Trojan Nuclear Plant
Docket 50-344
License NPF-1
License Change Application 62

Pursuant to discussions with members of your staff regarding License Change Application (LCA) 62 which proposes to modify the logic to the reactor coolant pump (RCP) trip breaker position trip signal to the Reactor Solid State Protection System, the following clarifying information is provided:

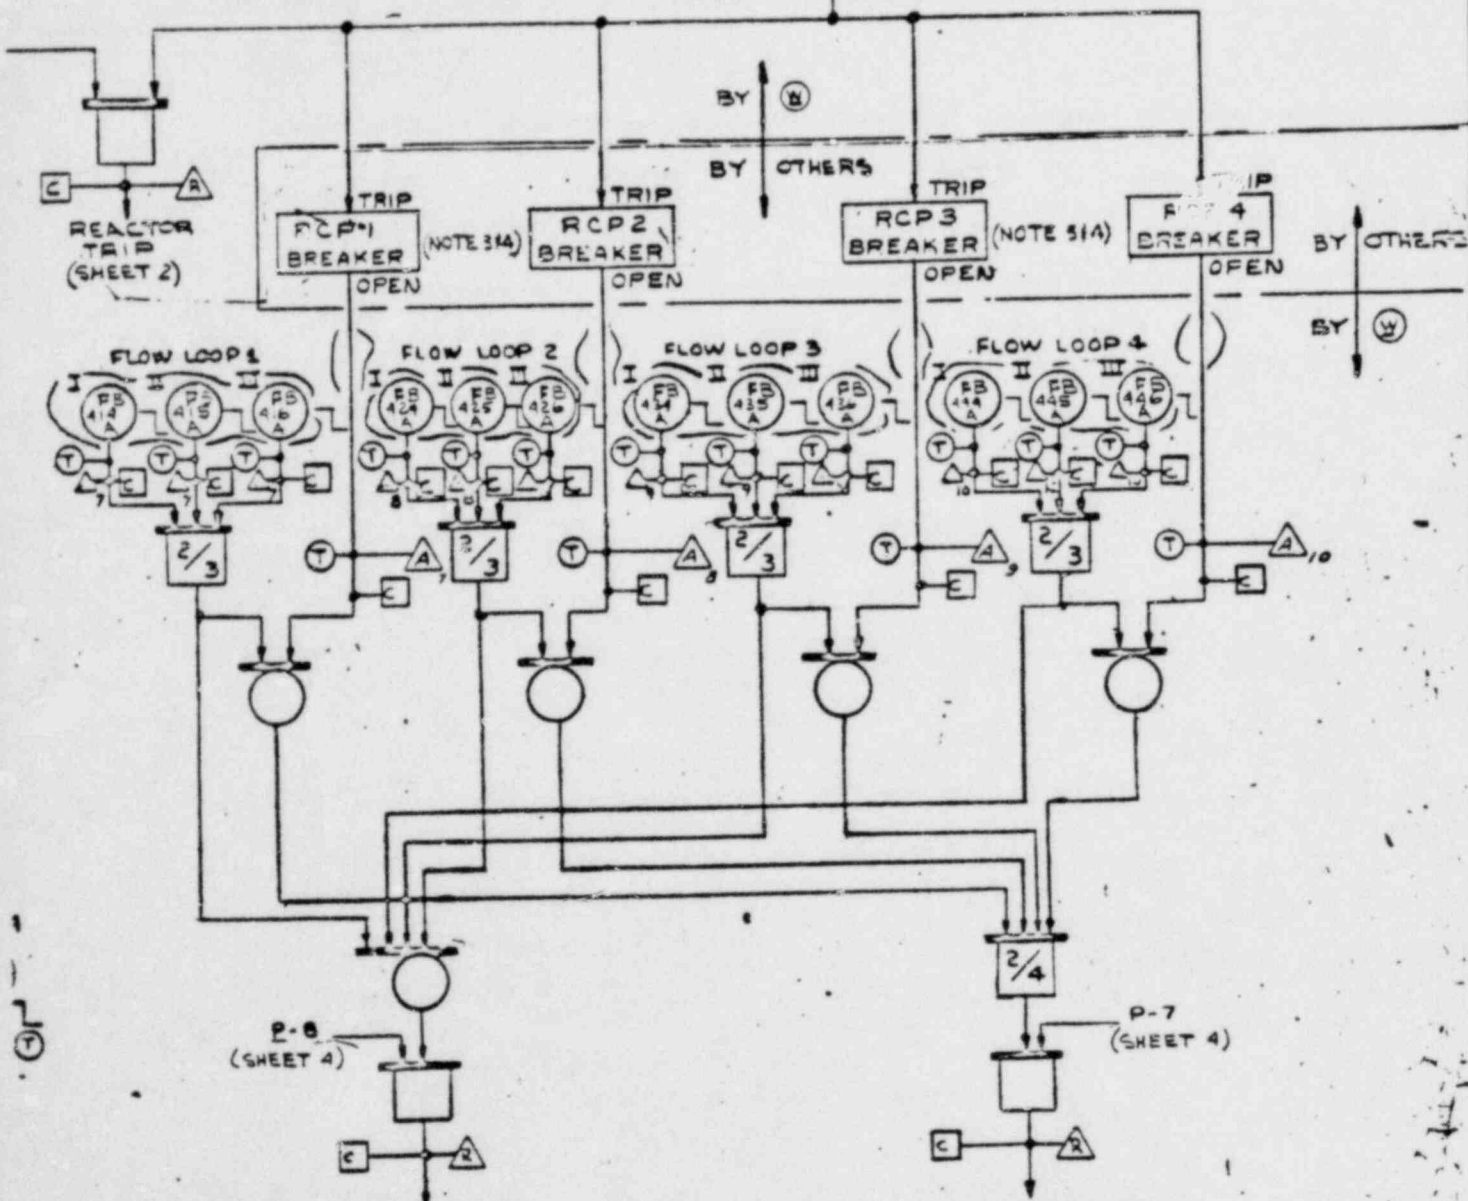
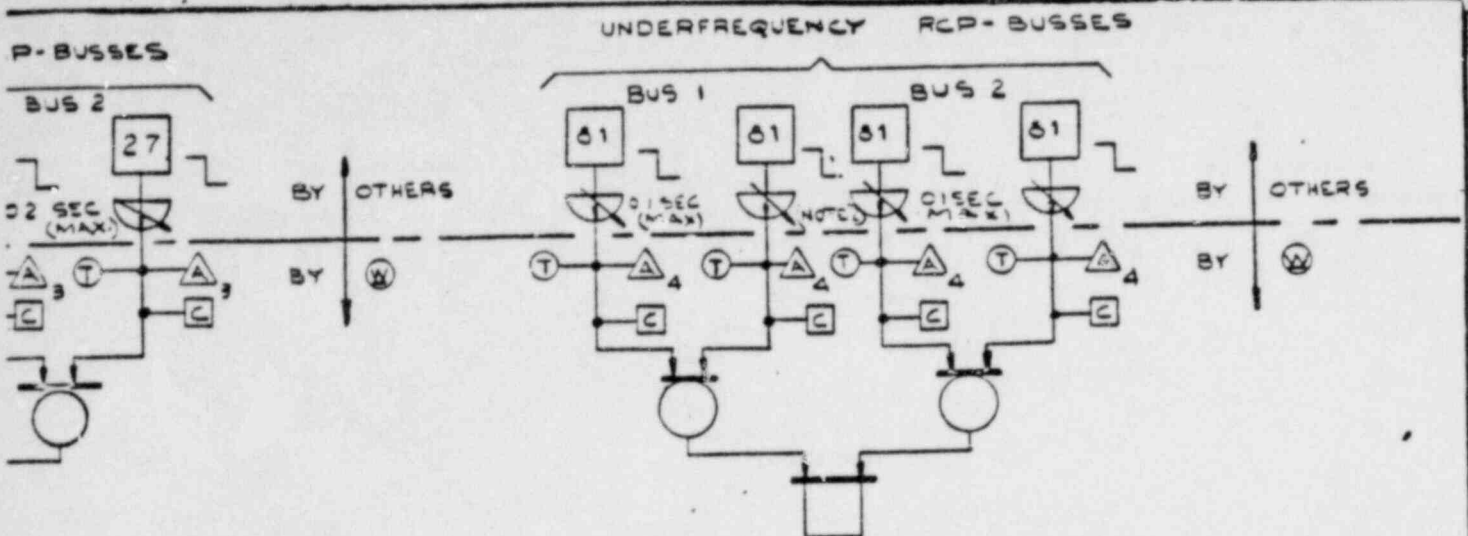
3. A copy of the revised logic diagram for a reactor trip caused by a low flow and RCP breaker position is attached. A revised second page (Page 2 of 2) of LCA 62 is also attached.
